From: Price, Wayne [WPrice@state.nm.us]
Sent: Thursday, October 28, 2004 9:44 AM
To: 'Randy Schmaltz'; Price, Wayne
Cc: Dave Cobrain; Foust, Denny; Hope Monzeglio; Robert Wilkinson; Chad King; Ed Riege; Dennis Tucker
Subject: RE: River Terrace

Re: Giant Bloomfield Refinery – River Terrace Sheet Pile Area

River Terrace Barrier Sampling Locations

Schematic Well Design
Giant Refining Co.

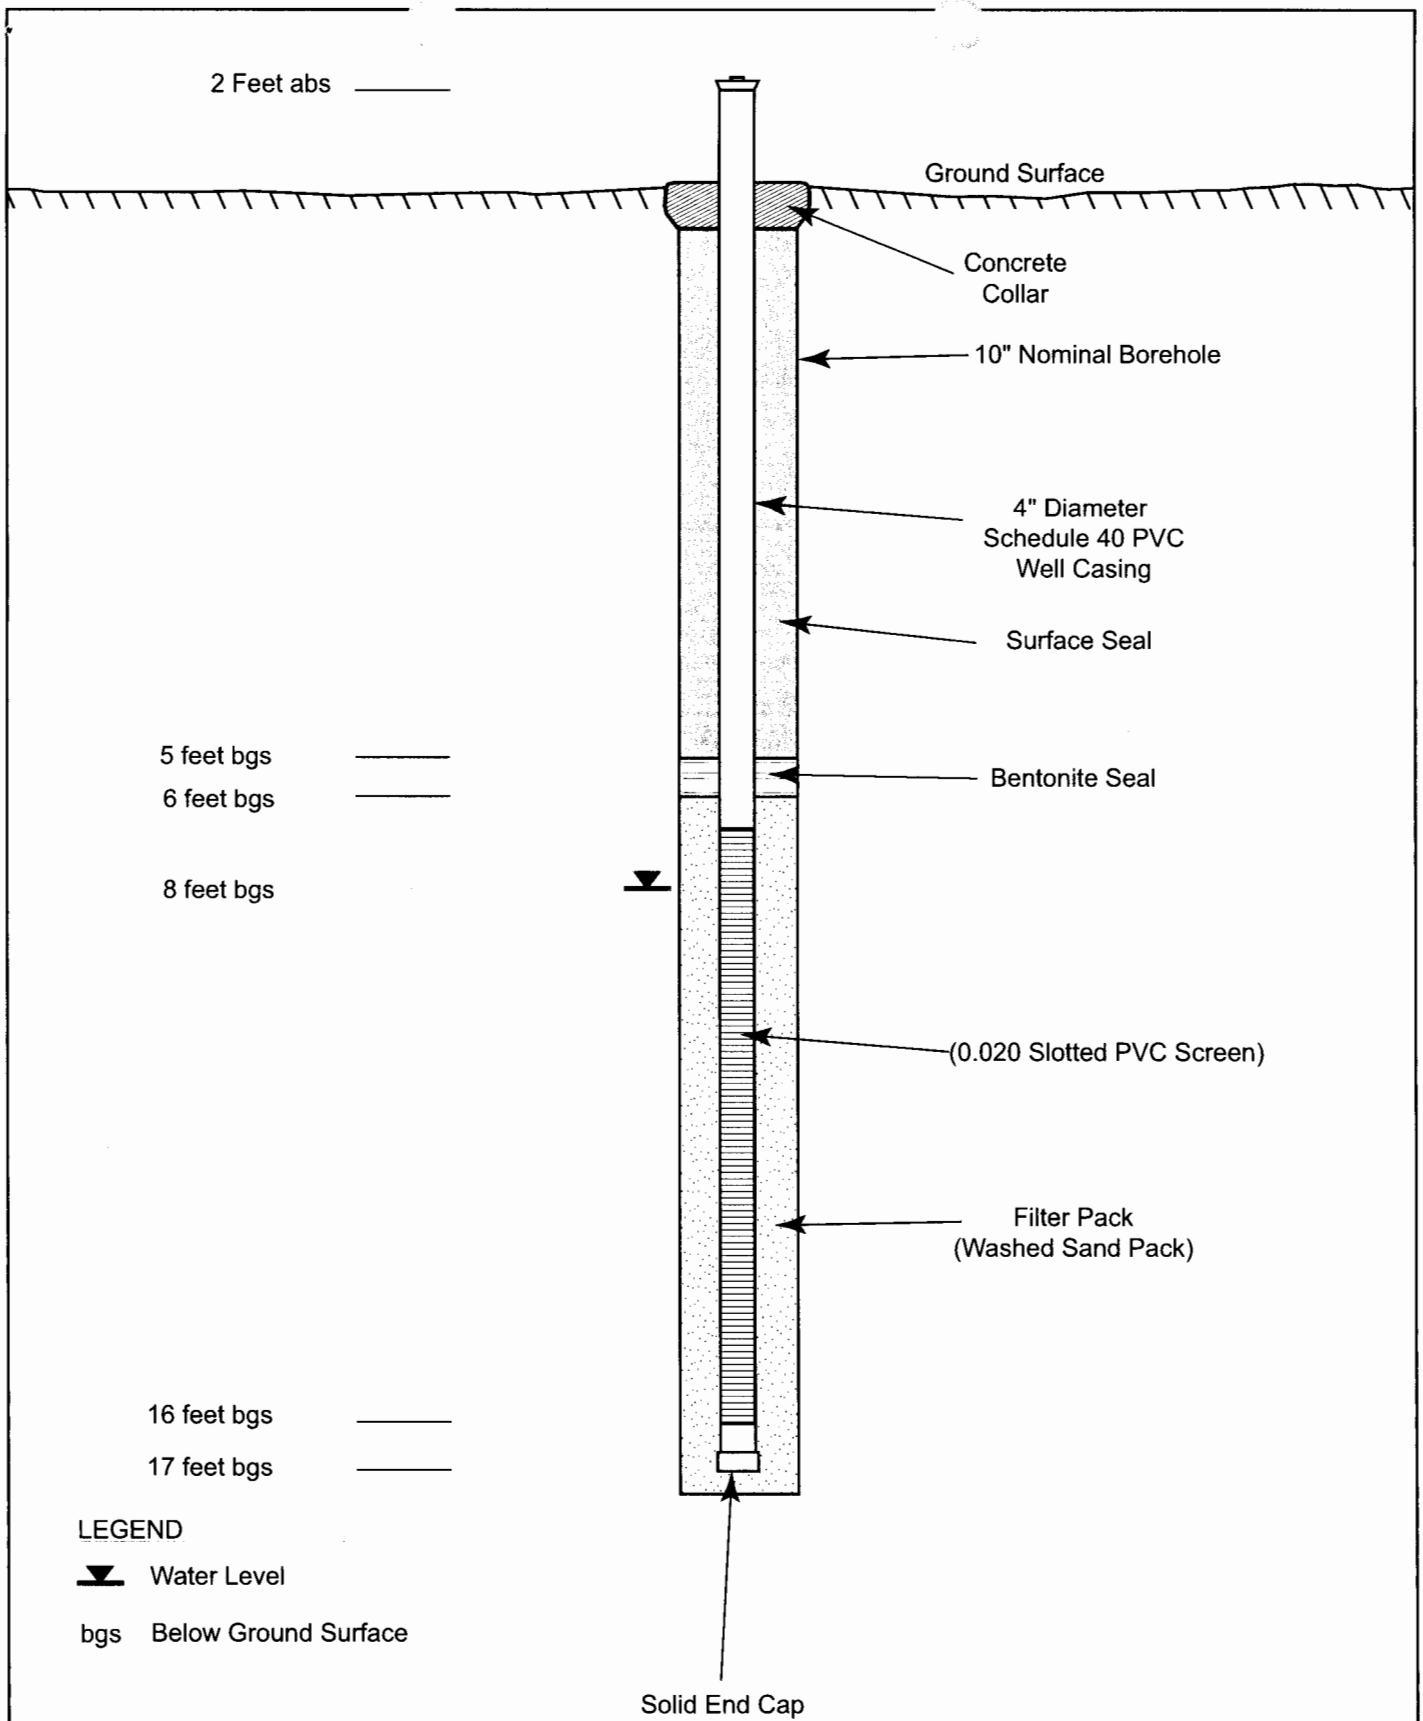
OCD approves with the following condition:

1. First round of sampling shall include general chemistry.

In addition to the two new wells, Giant will collect groundwater grab samples from up to eight spatially distributed locations across the river terrace to assess the lateral extent of potential groundwater impacts behind the barrier. The attached photograph shows the planned locations for the grab samples. The exact locations of these samples will be finalized in the field based on drill rig access. The groundwater samples will be obtained by advancing a borehole and placing a temporary two-inch PVC well casing and screen. After collecting a sample, the casing will be removed and the borehole will be properly abandoned. The samples obtained will be analyzed for the following parameters: TPH (EPA 8015 DRO and GRO) and BTEX/MTBE (EPA 8021).
